Macquarie Park

Ground Floor Plan

Scale	1:300@A1 / 1:600@A3	
Drawn	ML	Checked BD
Project No.	S10758	
Status	SK	
Plot Date	9/4/18	
Plot File	S:\S105-18199\A2\18_dwg_mech\as18199a2\plot_a2_2017\A13.00.dwg	
Drawing No.	A03.00	[Revision] 02

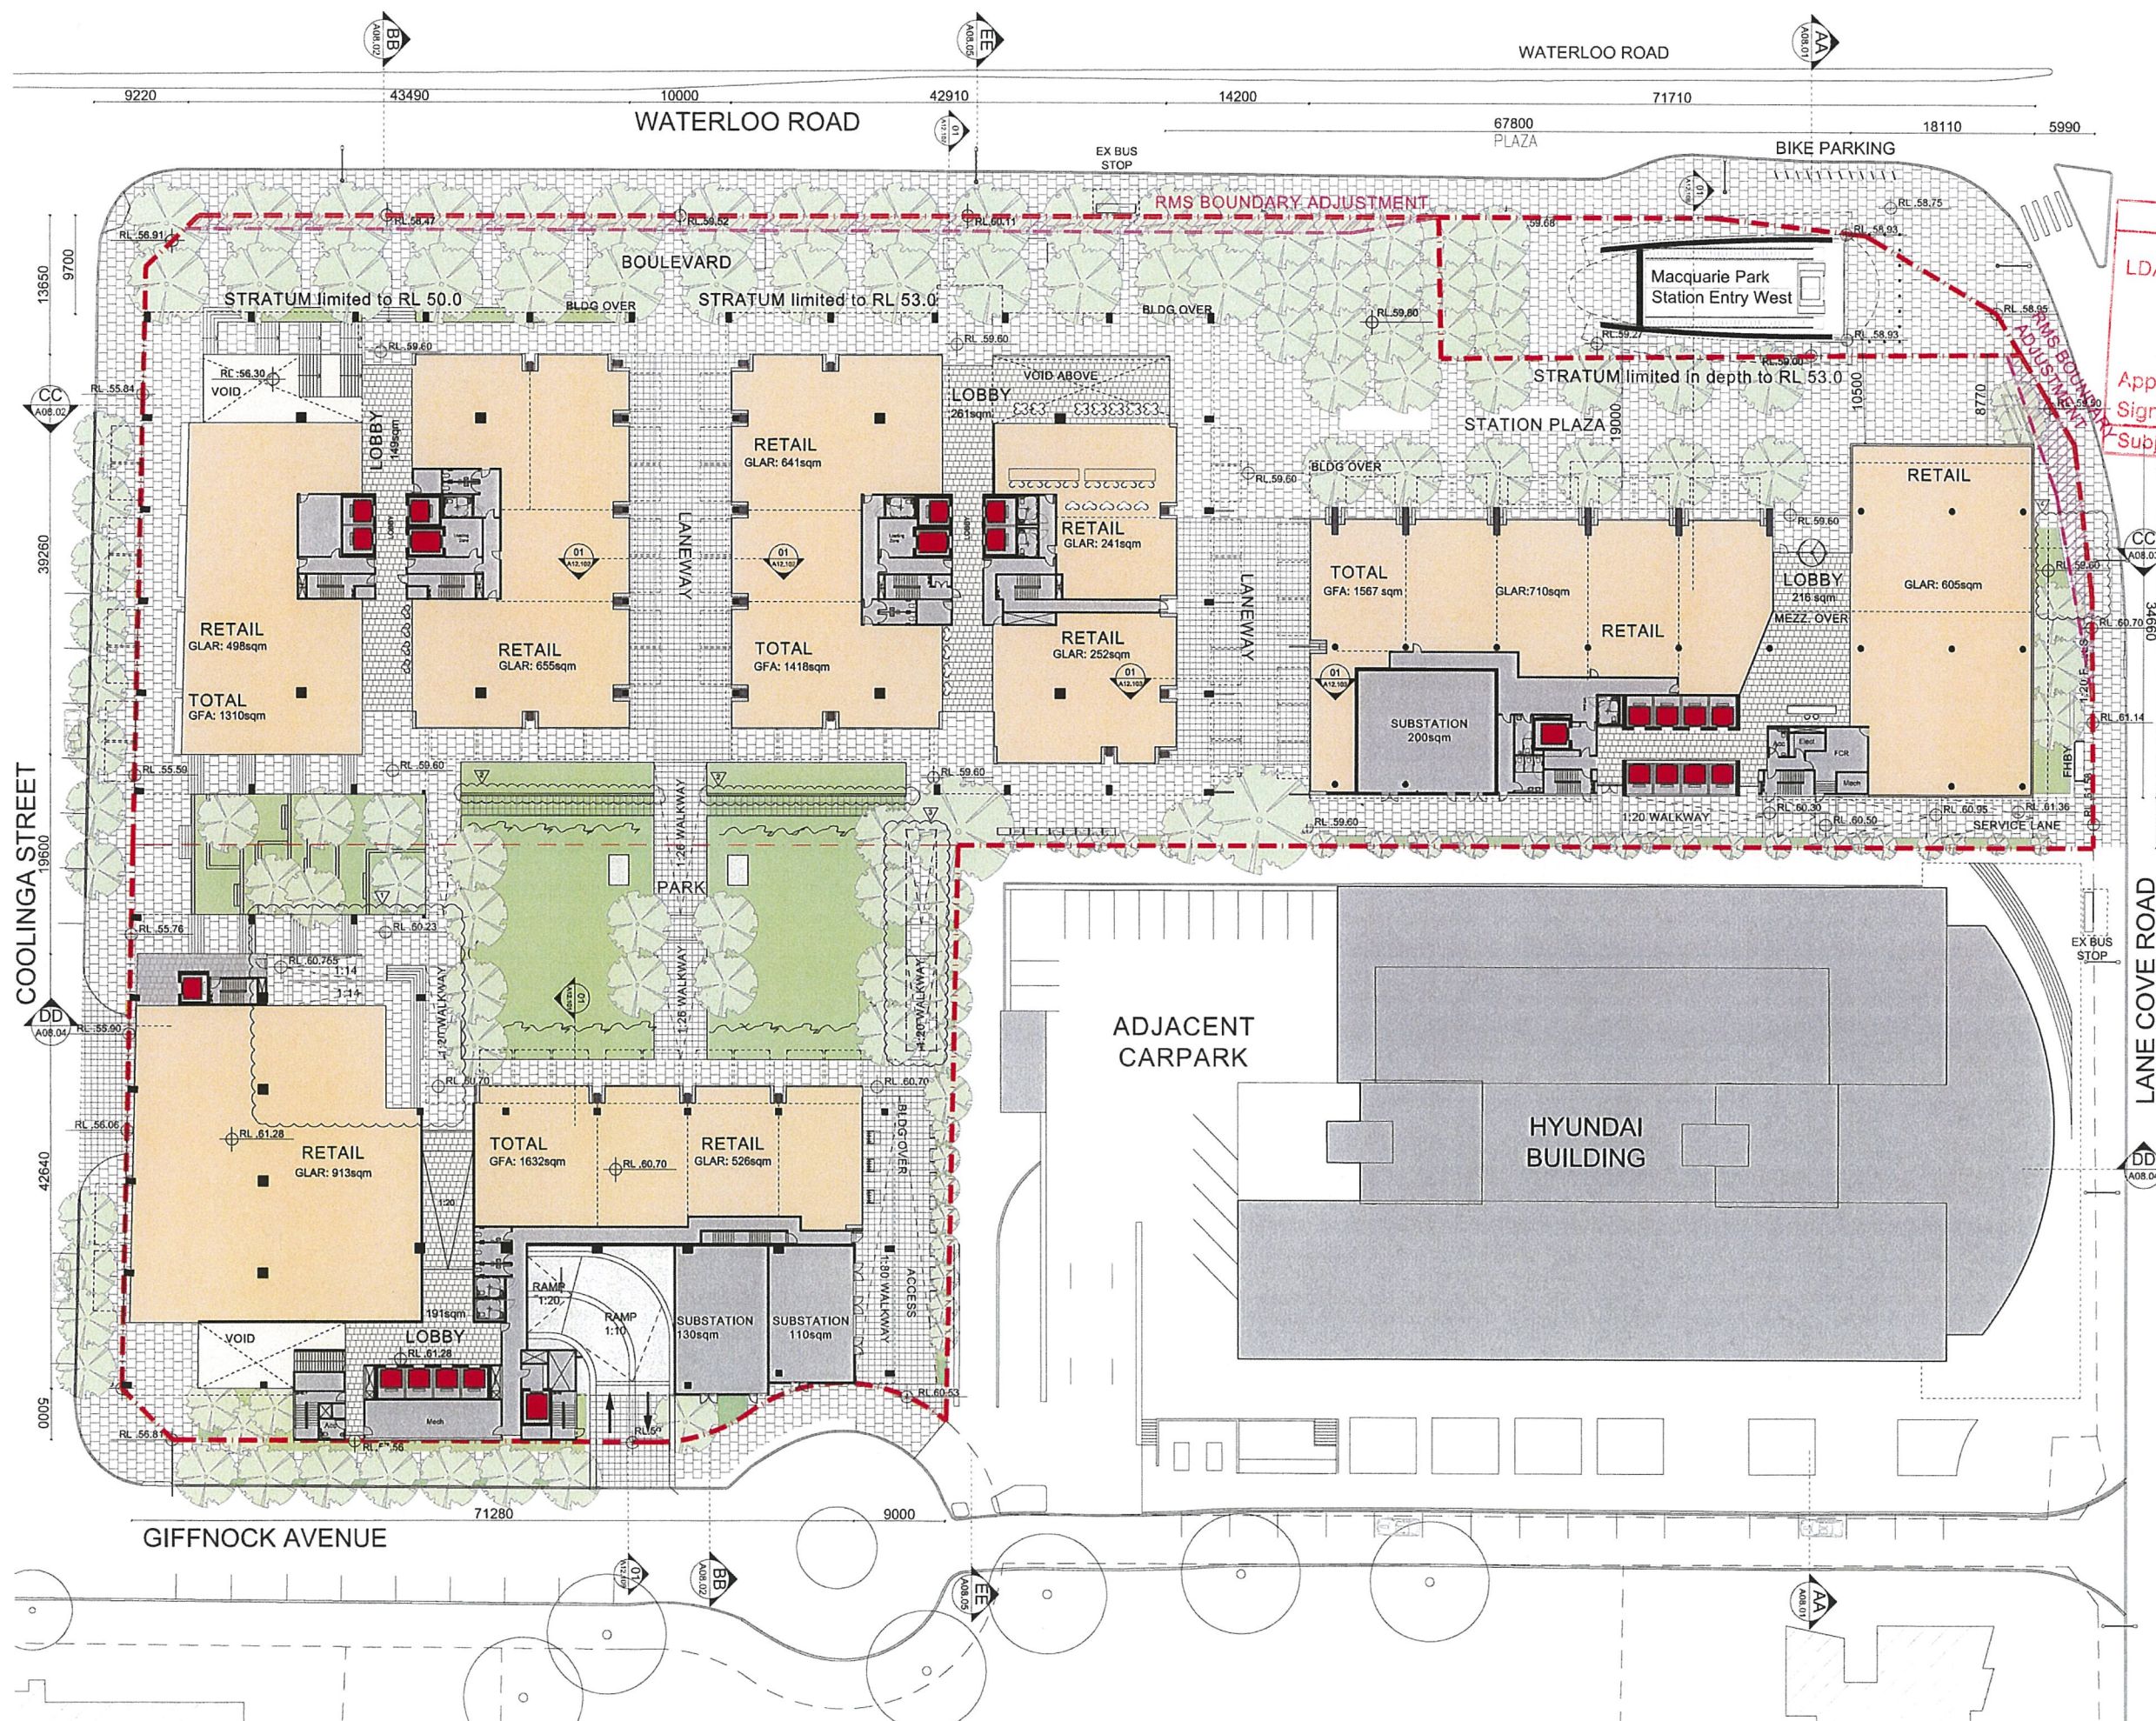
1. Car park crest level along Coolinga Street raised to RL 56.43 resulting in raised building D ground floor slab and new integration with public domain
2. Rain garden design integrated with park
3. New park pavilion along eastern frontage to supply further weather protection
4. Relocated planter outside RMS boundary
